**RE: Pirates Cove parking concerns**

Re: County File Number: DRC2011-00069  
Hearing Date: May 23, 2013  
Pirates Cove Coastal Development Permit

Subject: CAVE LANDING AREA IMPROVEMENTS

**DRAWING 1 - CONCEPTUAL ILLUSTRATION FOR ADDITIONAL PARKING & TRAIL RE-ALIGNMENT**

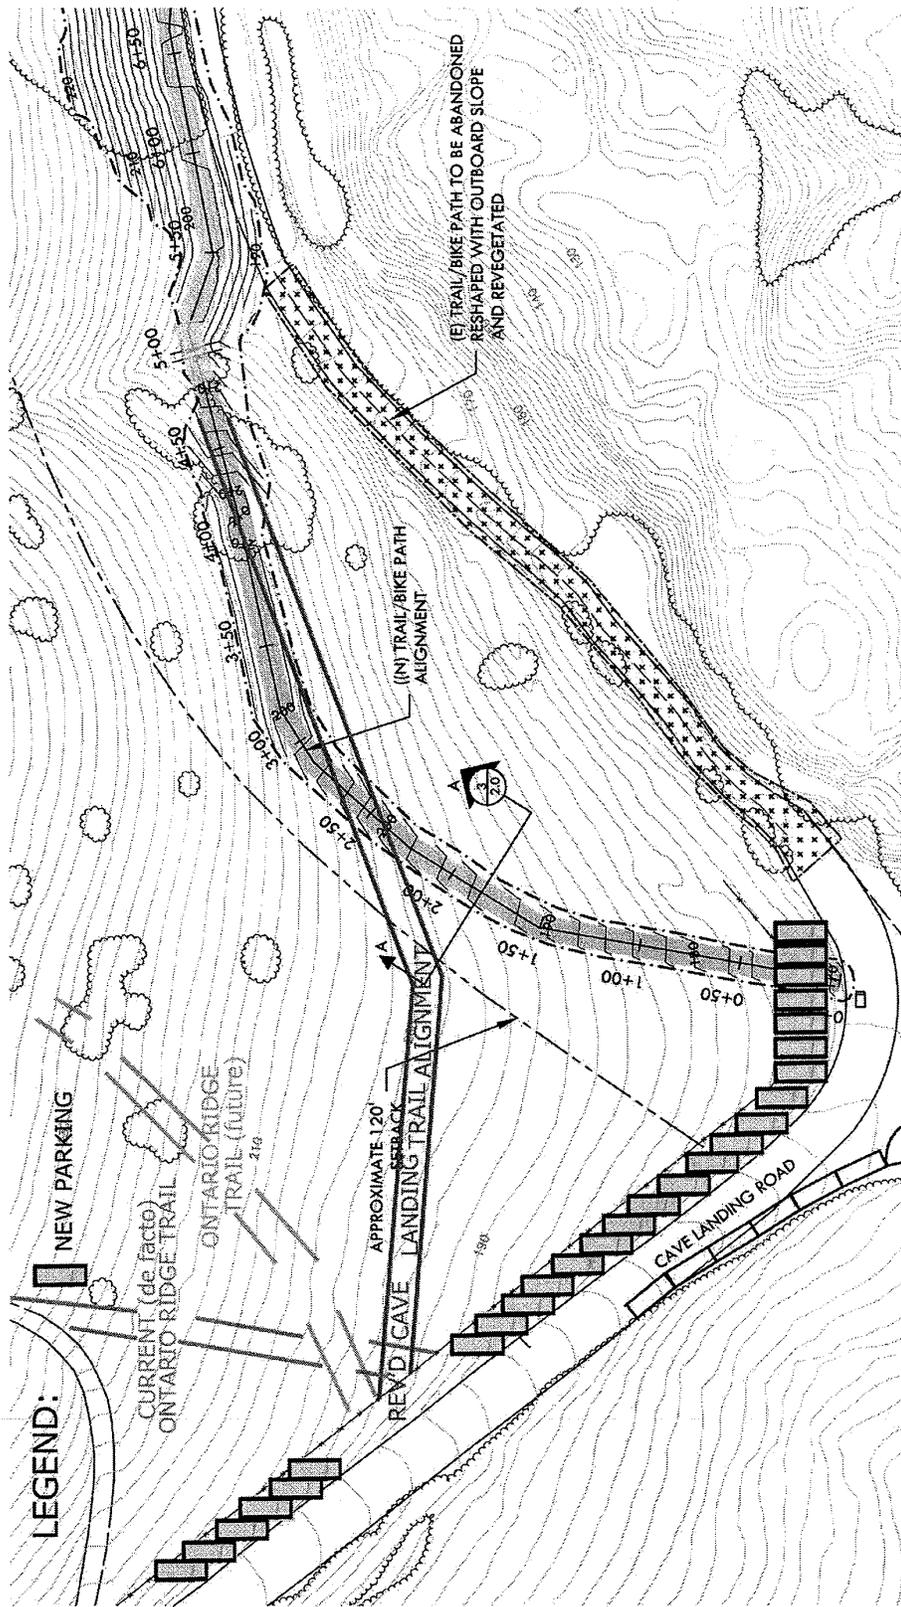
The following conceptual **DRAWING 1** is a mark-up based upon one of the sheets obtained in an internet search of available documentation regarding SLO Parks' Dept. plans for the Cave Landing parking area. The main concept is that angled parking in the down-hill direction of Cave Landing Rd be established on the South-West portion of Parcel 3 of 54PM36 owned by the County of San Luis Obispo. By converting the current parallel parking along Cave Landing Rd, to angled parking, better utilization of space is obtained with an increase in available parking while maintaining necessary fire lane consideration.

There is currently approximately 400 or more, linear feet along this SW portion. There is an existing 50' wide road easement (which is no longer a concern on SLO owned Parcel 3); the road is currently about 26' wide. There is more than adequate area to accommodate this proposal with very little grading requirements. The excavated material could be placed along the westward remaining 12' of easement and allowed to naturally compact, and potentially utilized in the future for further parking availability.

PROJECT	CAVE LANDING ROAD PARKING STUDY FOR WHALES CAVE CONSERVANCY
DRAWN BY	SAN LUIS OBISPO COUNTY
SHEET TITLE	CONCEPTUAL OFFSITE PARKING & DRAINAGE SITE PLAN
DATE	MAY 15, 2013
SHEET NUMBER	0.2
TOTAL SHEETS	2 OF 2 SHEETS

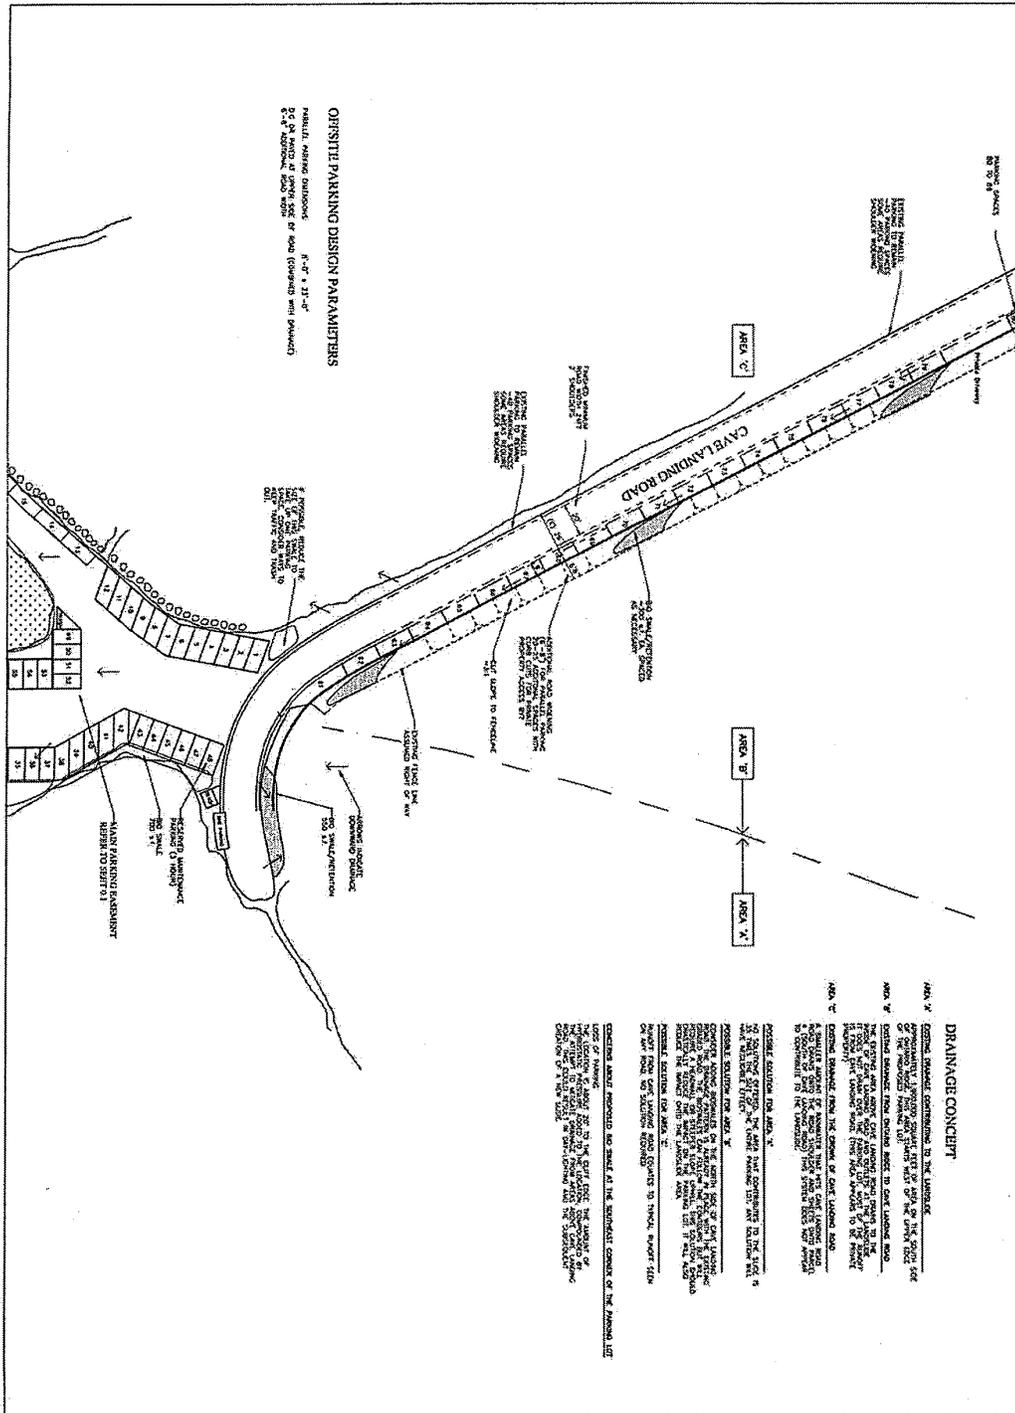
We hope our many years of experience in this area will be of benefit to the County and to the many new people that will "discover" Pirates Cove. With Parks and Rec revisions to date, we are still at 29% fewer "legal conforming" spaces (Even more if actual parking is considered). In our meetings with Parks and Rec, and San Luis Obispo Planning, we have come to the conclusion that the parking to make up for the loss is not possible within the confines of the parking easement. The most efficient of the options would be to re-establish parking on the North side of Cave Landing Road. While this will take some road widening it should get us close to the existing available parking. (See Exhibit "C" Schematic Offsite Parking Plan)

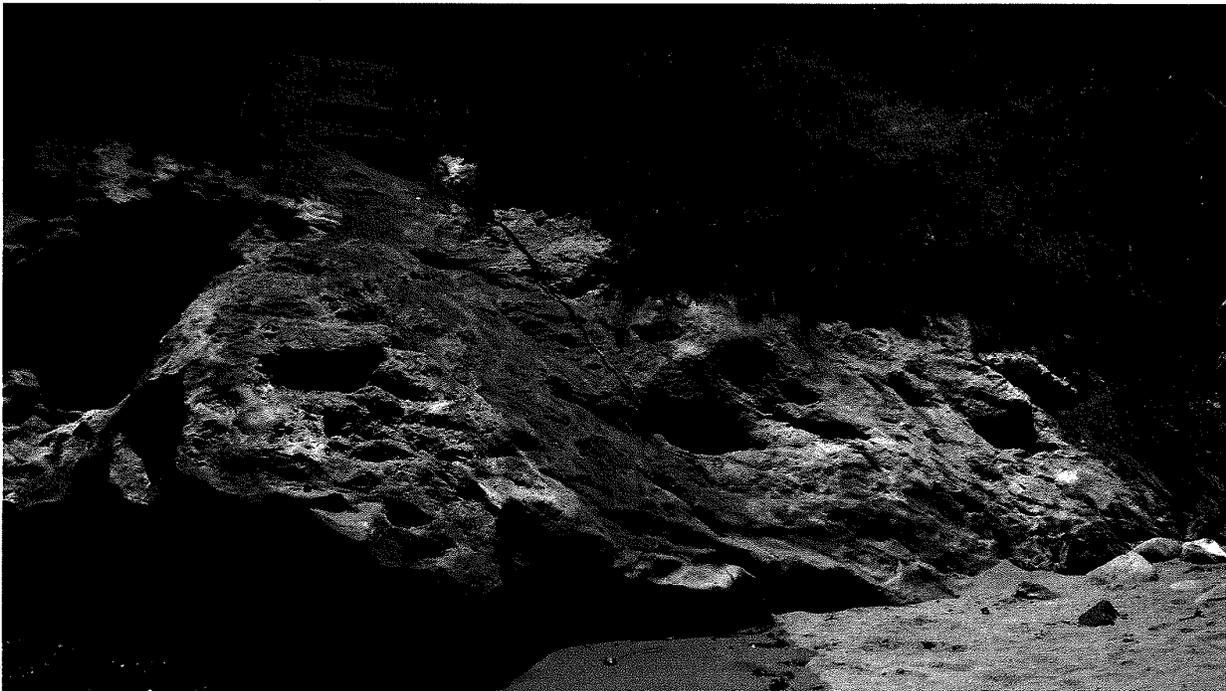
If we consider the fact of the multiple impacts upon this staircase from the rocks/boulders during the winter storms, along with the significant wave forces, it should now be apparent that a concrete staircase in this area would sustain damage EVERY winter, and most certainly be rendered into a crumbled mass of rusting rebar within 3 years.

**My fear and apprehension is that the County would be required by Cal-OSHA or some other ordinance / regulation to preclude use of the staircase, thus SEVELY limiting "Coastal Access".**

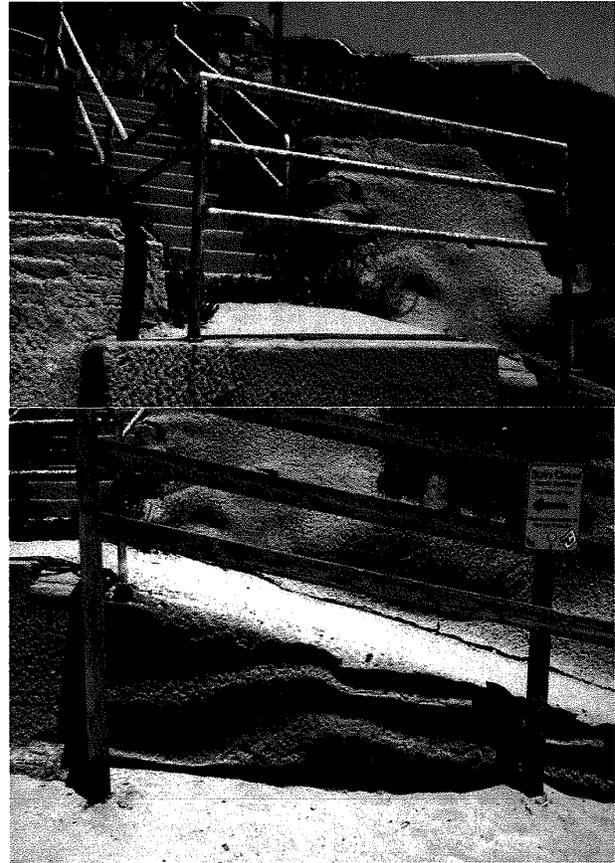
As can be seen above, there is a natural L-shaped "fall line" in the rock to sand level (follow rope then to the right). As stated before, this is the primary access to the beach during winter months, and secondary access

during non-winter. Improved rough-hewn steps could be carved into this rock, and serve as the improved beach access.

These “steps” would still be subjected to impacts by the multiple rocks/boulders, however, since it is already a “time tested” surface, it would have a much higher use life than the proposed concrete stairs, and would completely avoid the rust/spalding issues resulting from the concrete rebar.

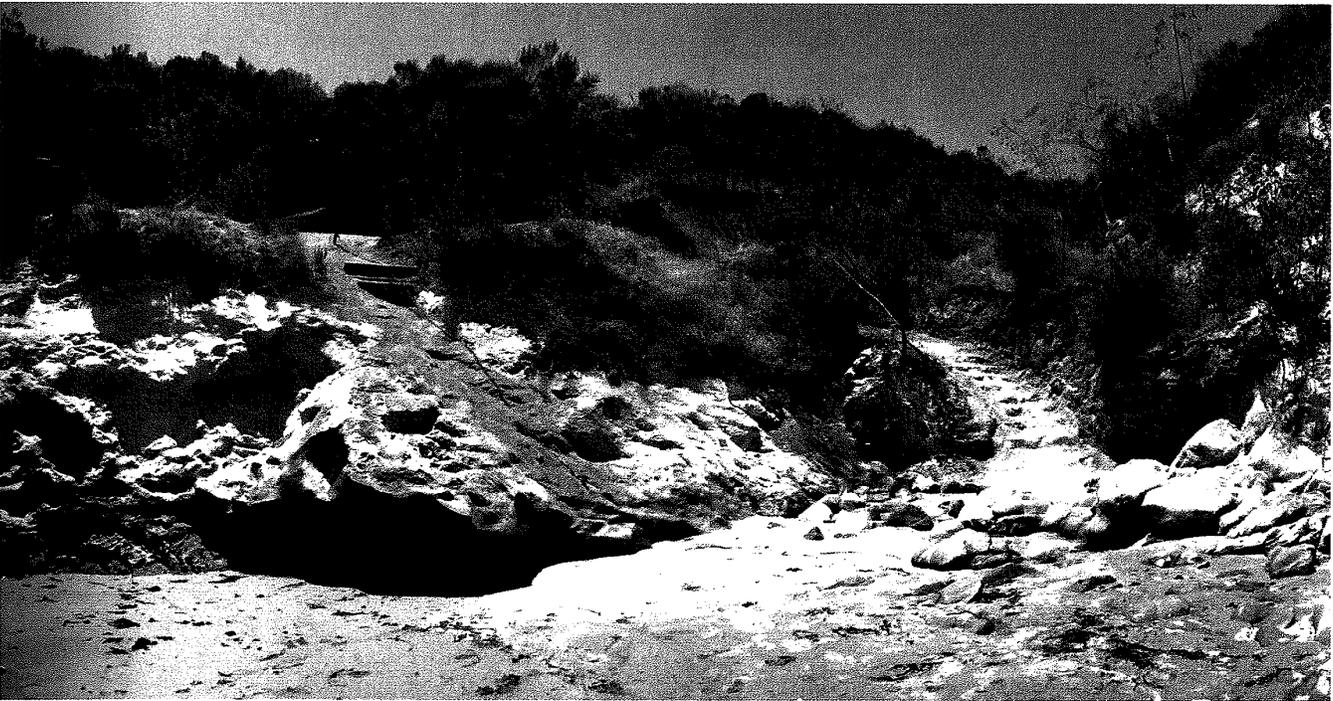
NOTE THE HAND CHISELED STEPS JUST LEFT OF CENTER, ALONG NATURAL ACCESS TO THE BEACH AREA. THIS WAS THE PRIMARY BEACH ACCESS PREVIOUS TO THE MID-1990'S, AND IS STILL OCCASIONALLY UTILIZED.

AGAIN, NOTE THE HAND CHISELED STEPS LEFT OF CENTER, AND "ROPE ASSIST" BEACH ACCESS. THIS WAS THE PRIMARY BEACH ACCESS PREVIOUS TO 2000'S DURING HIGH TIDE, AND IS A SECONDARY ACCESS TODAY. ALSO NOTE THE HAND CARVED STEPS IN MUD/CLAY AT RIGHT. THEY ARE THE PRIMARY POST-WINTER BEACH ACCESS. THE STEPS ARE LOCATED IN THE LAND-SLIDE AREA, AND ARE RE-CARVED **EVERY** YEAR.

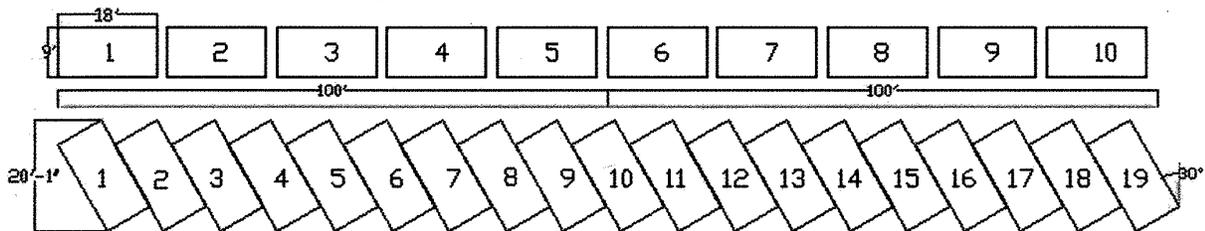
The first sentence specifically states, “improved” parking for 100 cars.

The second sentence specifically states that a “permeable material” be used for surfacing.

**Therefore, further refinement of Parks plans is required to conform to the currently approved Coastal Development Plan for this area.**
